Drawing Title  
**DRURY TOWN CENTRE - EDGE TREATMENT & KEY CONNECTIONS**

PROJECT NAME  
**DRURY TOWN CENTRE STAGE 2**

Drawing No.  
**00-1101**

Drawing Title  
DRURY TOWN CENTRE - BUILDING FOOTPRINT

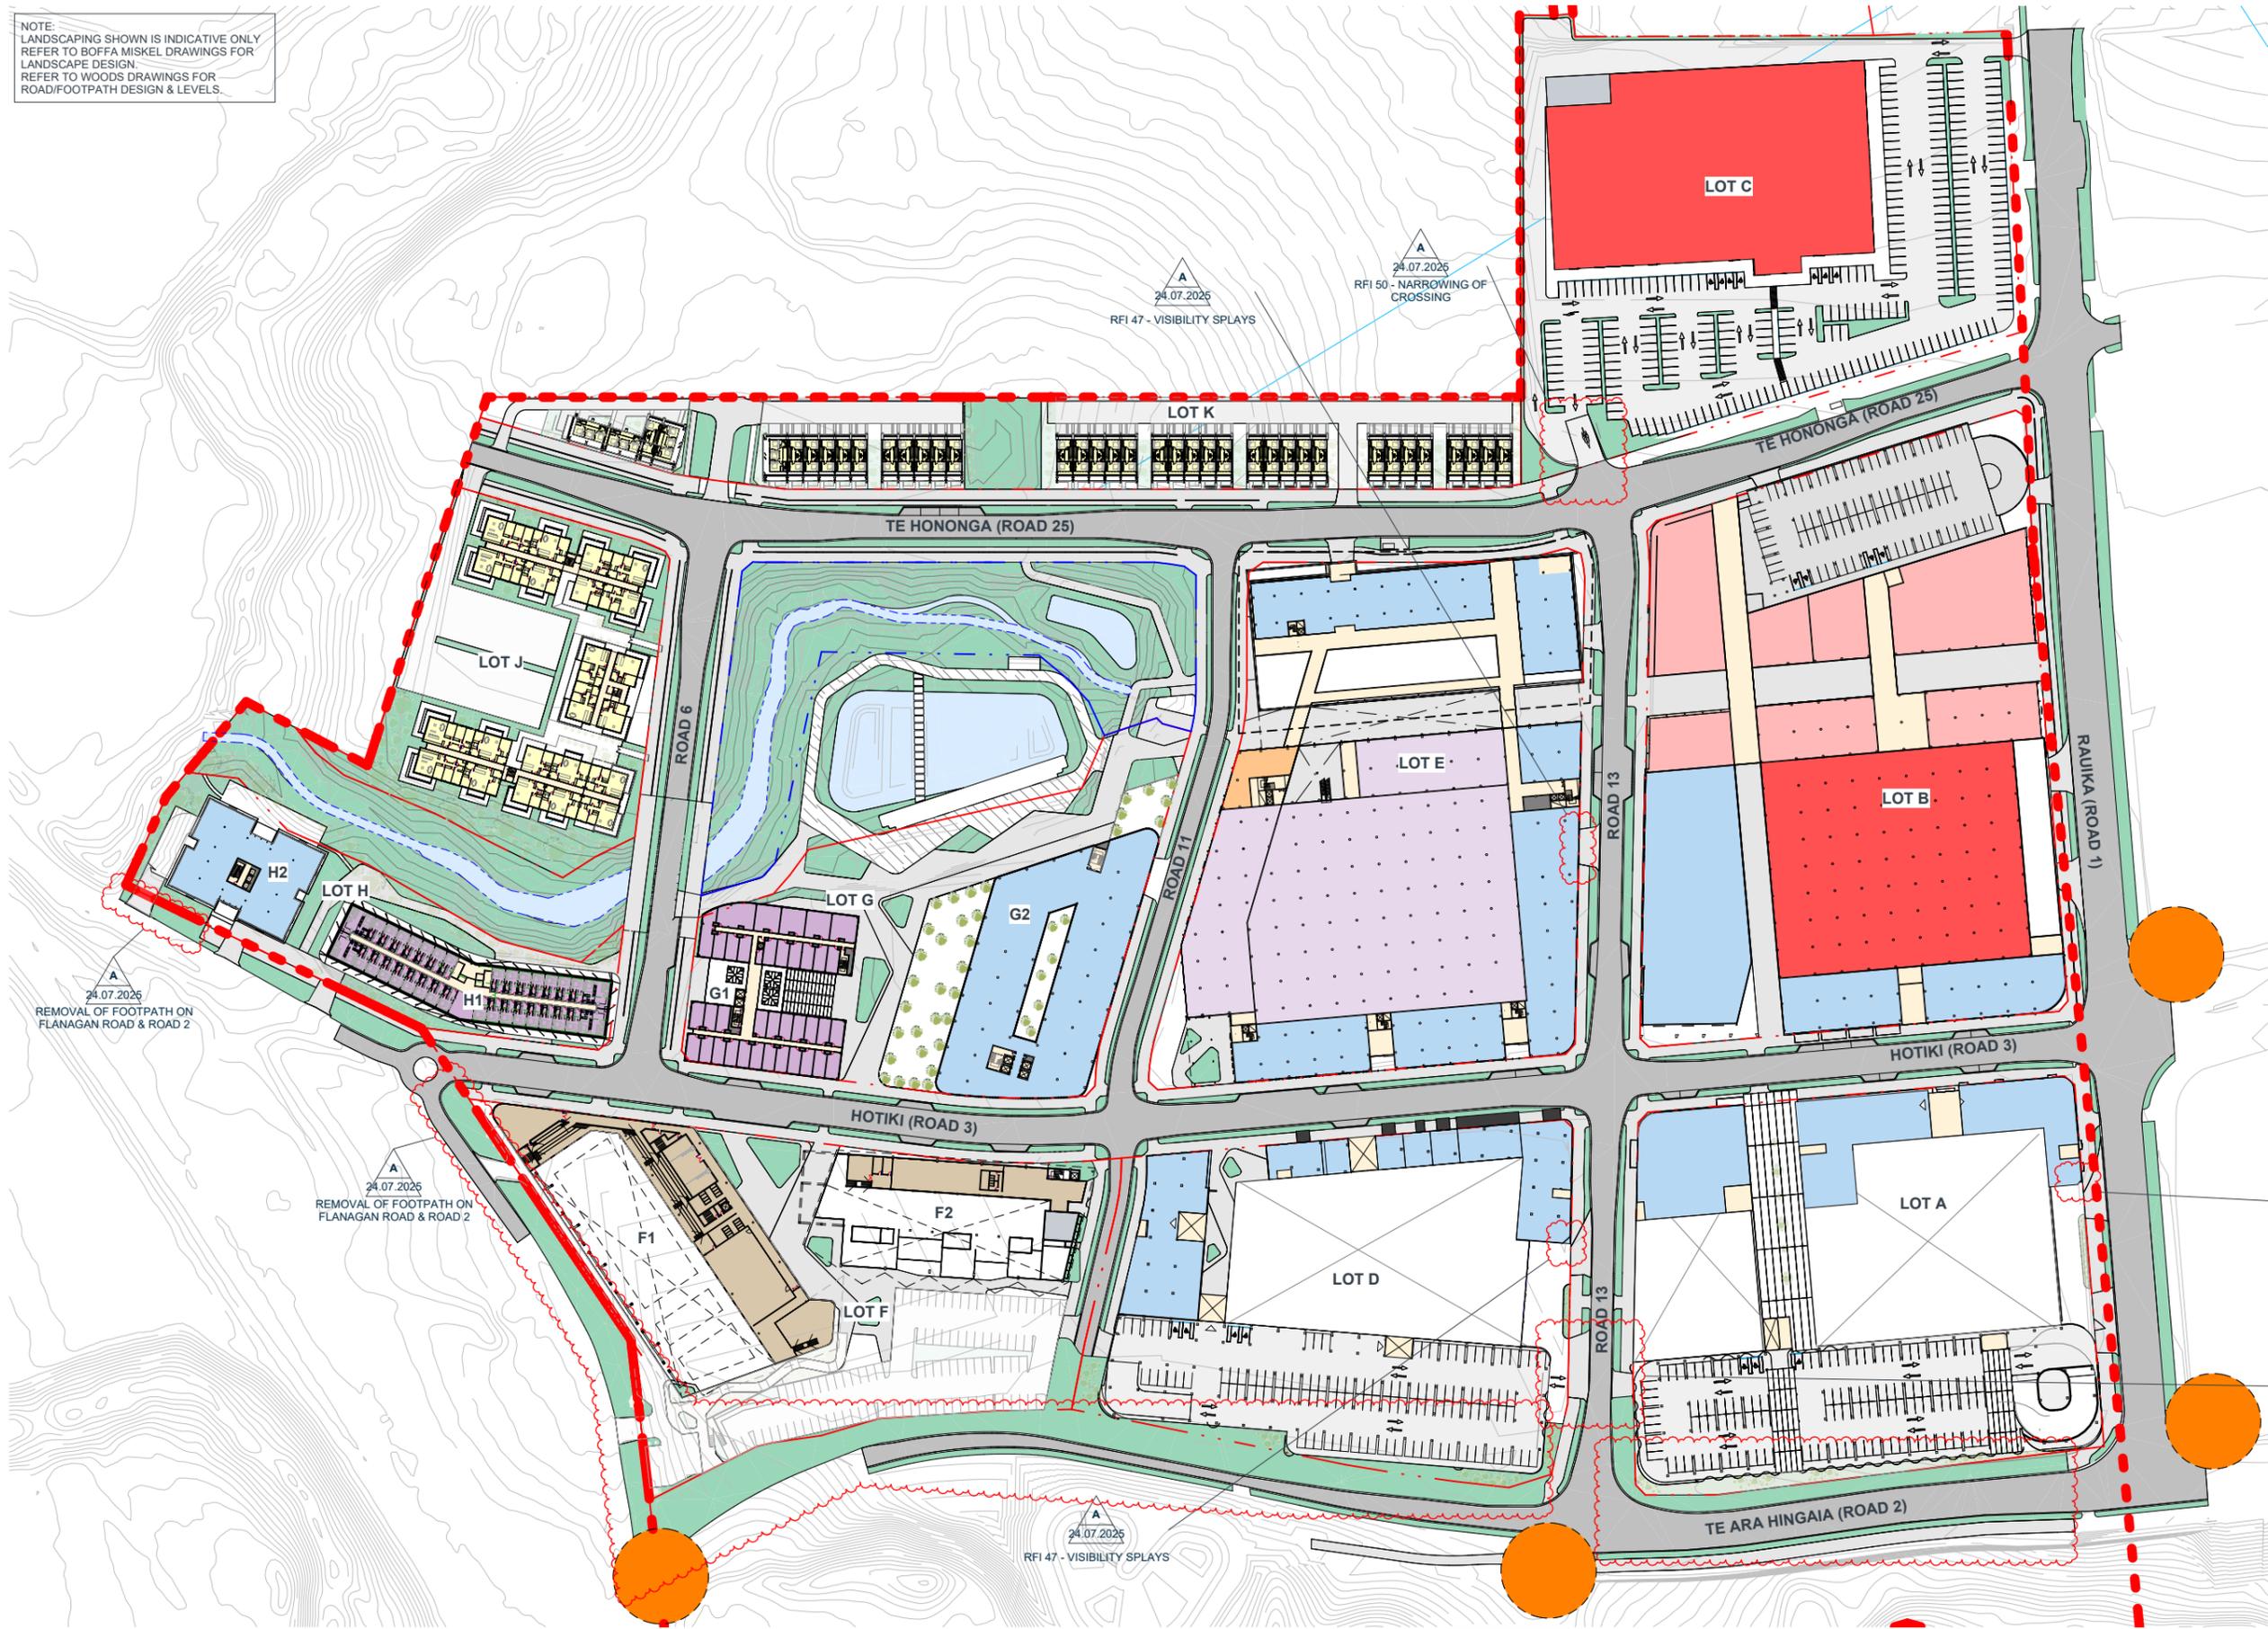
24.07.2025  
RFI 41 - REMOVAL OF FOOTPATH  
ON FLANAGAN ROAD & ROAD 2

24.07.2025  
RFI 41 - REMOVAL OF FOOTPATH  
ON FLANAGAN ROAD & ROAD 2

24.07.2025  
RFI 47 - VISIBILITY SPLAYS

24.07.2025  
RFI 50 - NARROWING OF  
CROSSING

24.07.2025  
RFI 47 - VISIBILITY SPLAYS

24.07.2025  
RFI 52 - ROAD 13 ENTRANCES

24.07.2025  
RFI 47 - VISIBILITY SPLAYS

Drawing Title  
**LOT C - LEVEL 00 - FLOOR PLAN**

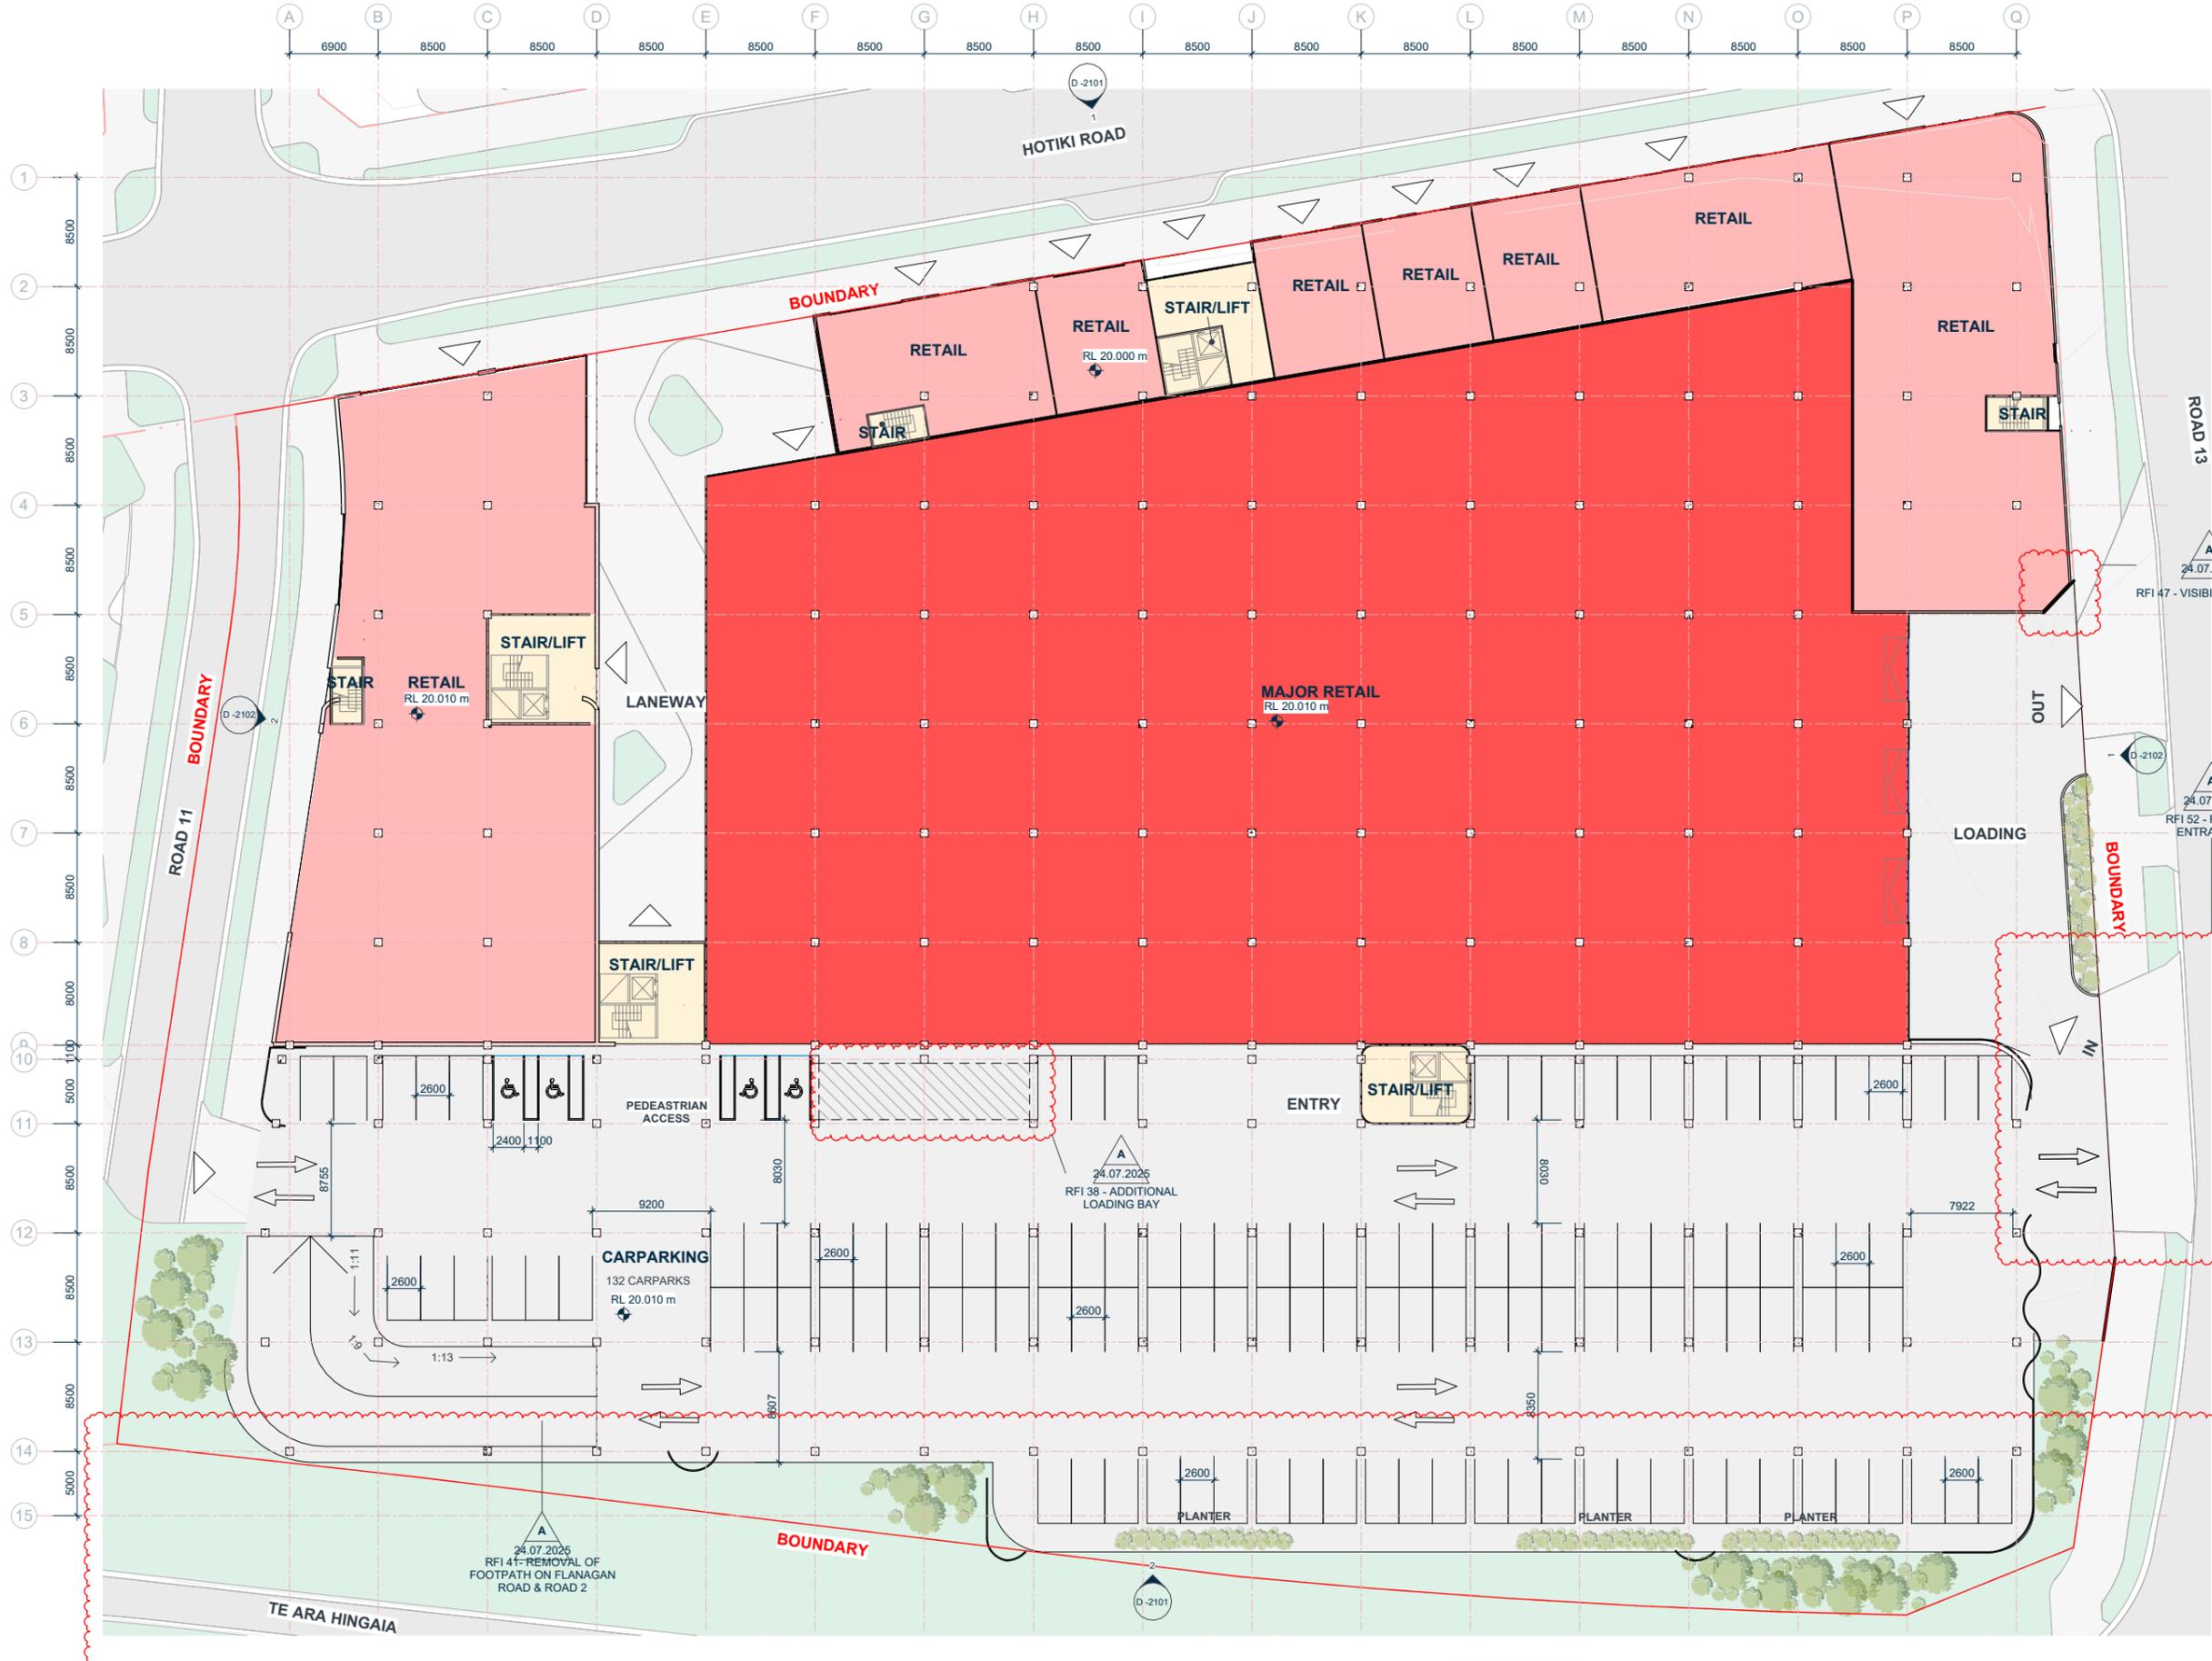
A  
24.07.2025  
RFI 50 - NARROWING OF CROSSING
